**DOCUMENT 00 90 00
ADDENDUM**

ADDENDUM: 3

PROJECT: WESTERN TECHNICAL COLLEGE
SPARTA PUBLIC SAFETY TRAINING SIM CITY
11177 COUNTY HWY 1
SPARTA, WISCONSIN 54656
PROJECT NO. 25039

E400

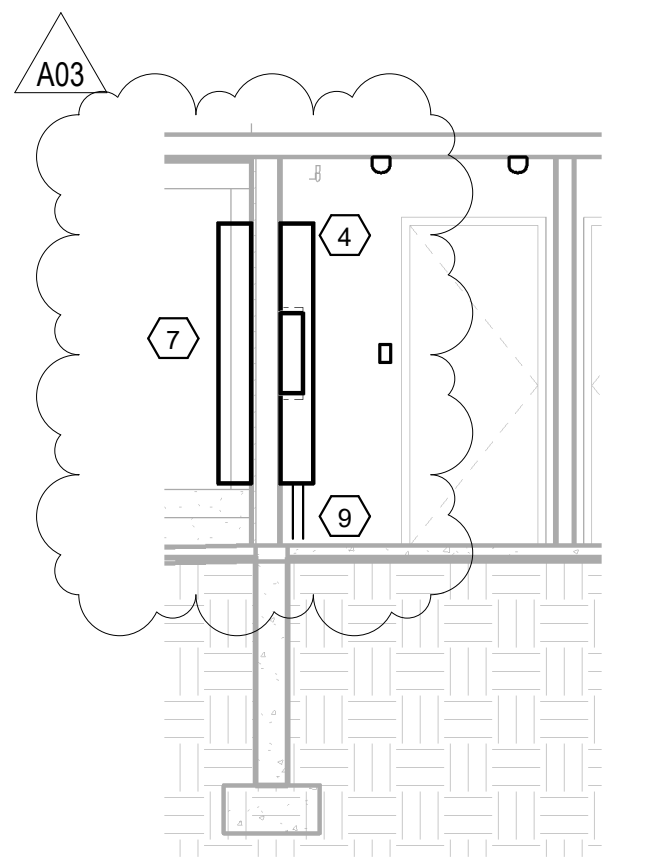
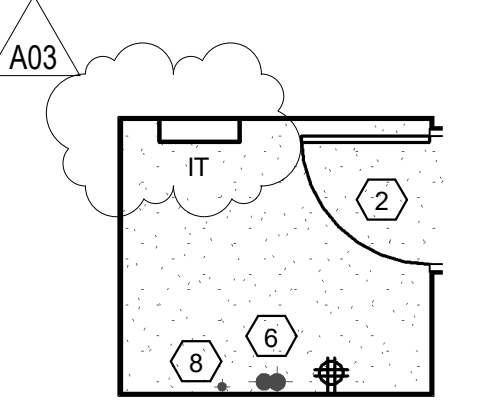
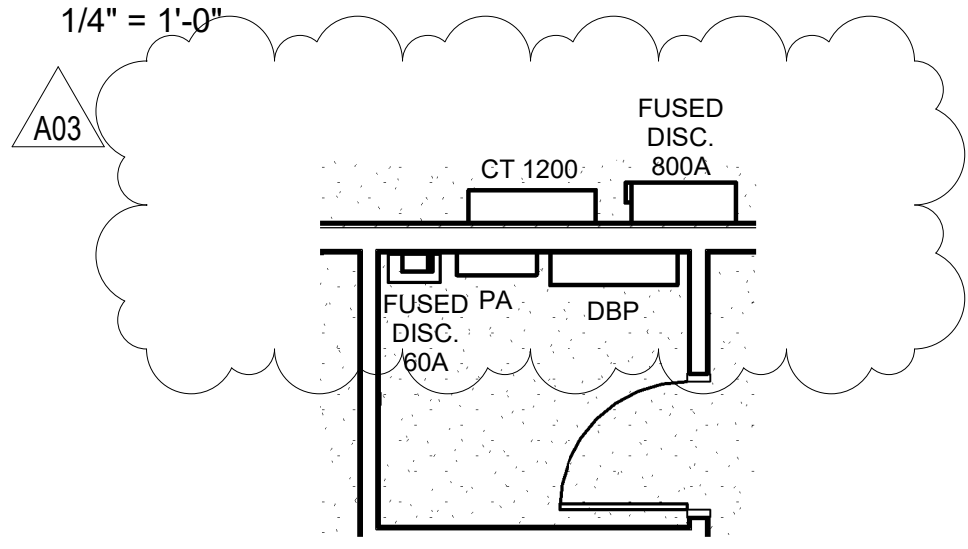
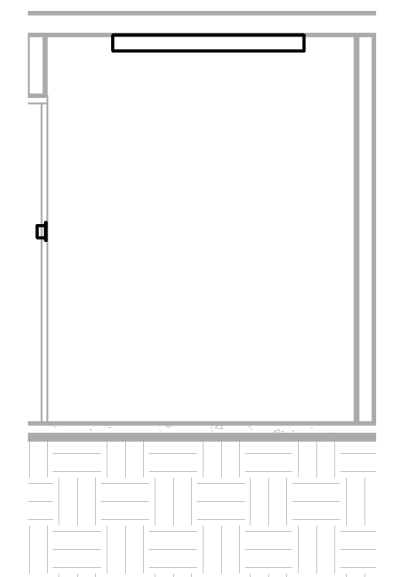
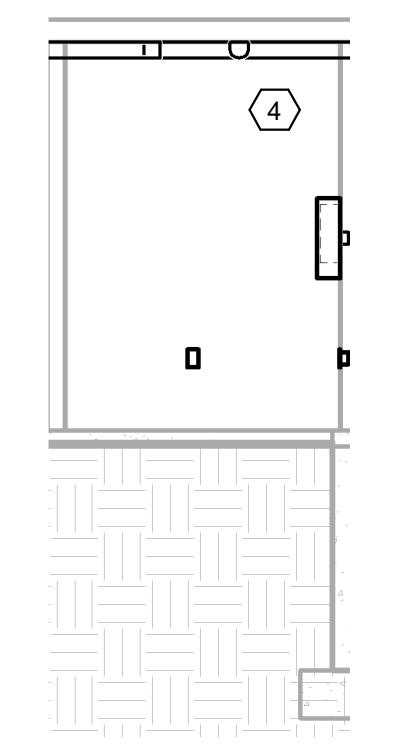
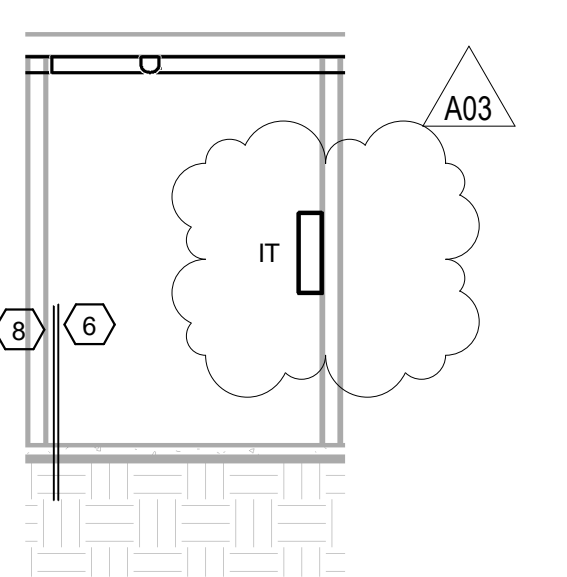
5. Sheet E400 Enlarged Plan 21"x30"
 - a. See the revised sheet included in this addendum. Disregard the previous version.
 - b. Revised panel locations and modified keynotes. See clouded changes.

E700

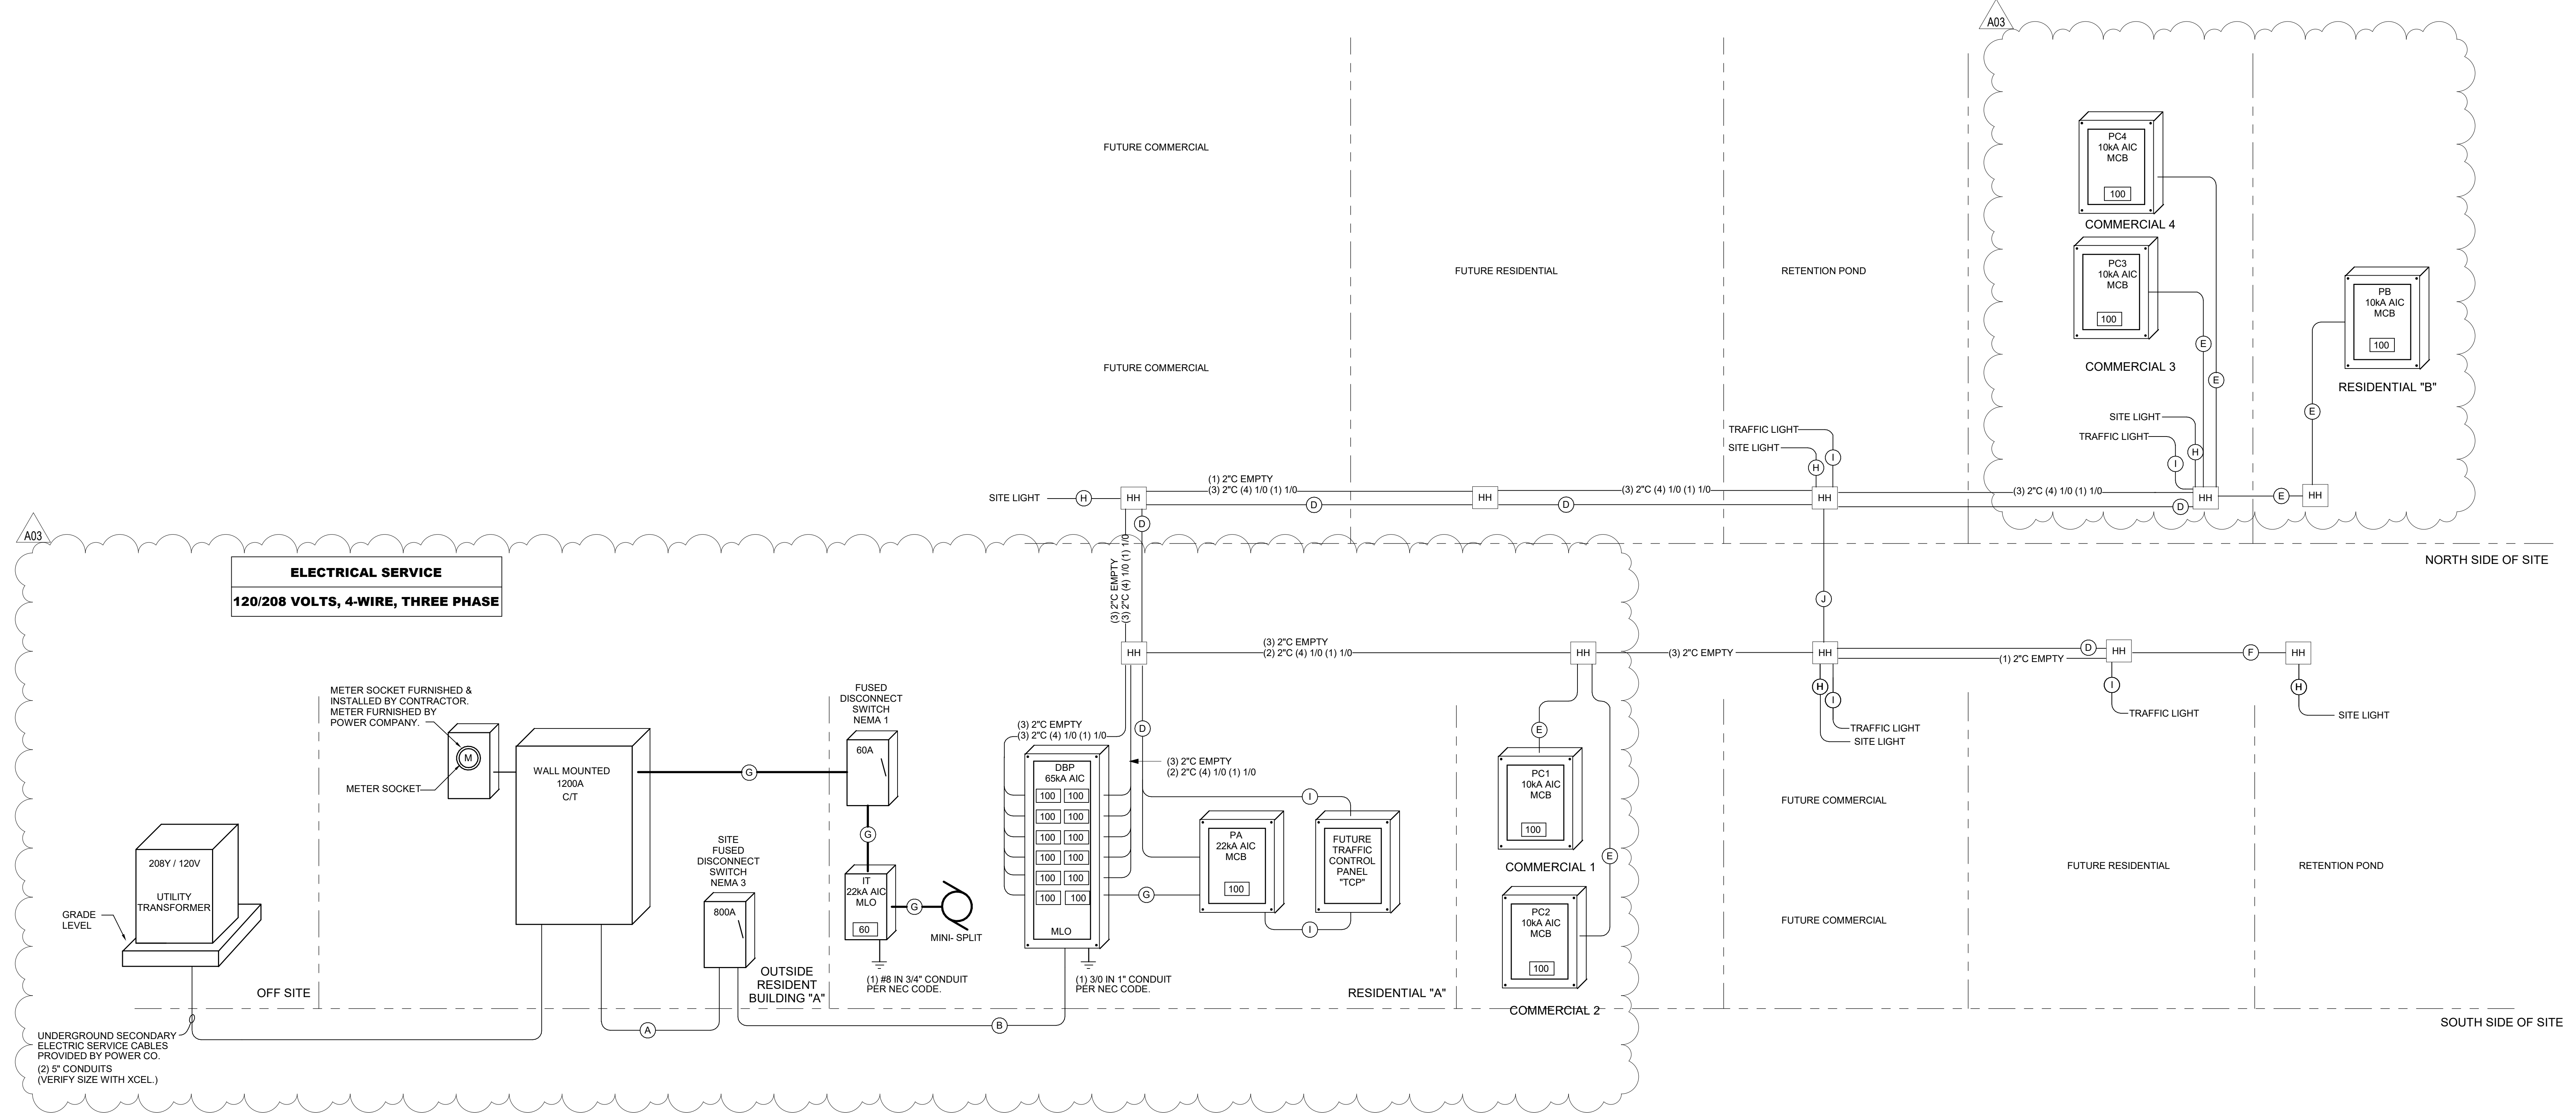
- c. Revised Light Fixture Schedule for product selection and added remarks.
7. Sheet E700 ELECTRICAL RISER 30"x42"
 - a. See the revised sheet included in this addendum. Disregard the previous version.

- b. Revised Riser Diagram. See clouded changes.
